PROJECT  
Rame Peninsula Traffic Management

Reply to questions raised by Rame Cluster Group

Comments on the final draft for review version of the Rame Peninsula Traffic Management.

Report Ref EDG0205/F1 rev A

Antony Junction Profile  
New Junction  
Option 3

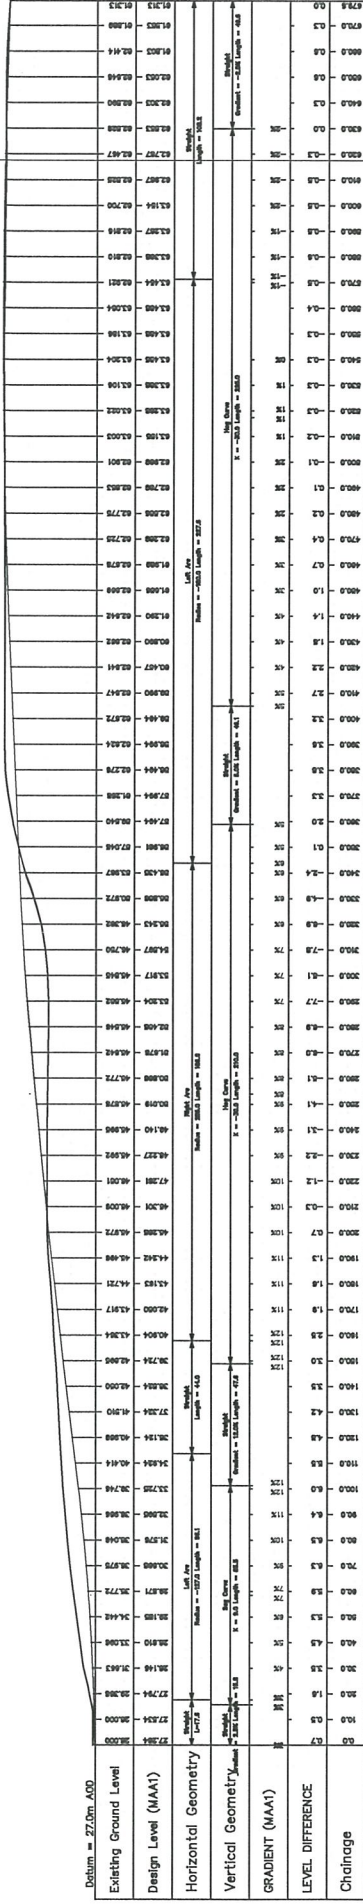
5. In Antony we support the recommendations for Junction option3 and also junction option 8. However, we are not convinced that option 5 is viable, because it will involve HGV's moving from a standing stop up the hill out of the village while also negotiating a sharp bend. Response: It is considered that option 5 would be viable as modern vehicles will be capable of negotiating the hill even from a standing start, it is accepted that this option will result in HGV's travelling through the village, but they will travel at a lower speed than if they were directed to travel downhill through the village. This option is also more likely to be buildable than the significantly more costly scheme options presented. Modifying the road layout at this location to allow HGV access through the village has a significant impact on route availability throughout the Rame network

6. The last sentence of section 7.4.4 is considered very weak. It should be replaced with words to the effect. It is therefore recommended that s desire to improve the junction via option 3 because it is central to the long term economic viability of the whole of Rame by providing a safe route for HGV's onto the peninsula and to provide for additional commuter traffic capacity to allow development on the peninsula.

Response: We cannot agree to this statement without a business case being produced. We will revise the report to clarify this. ."
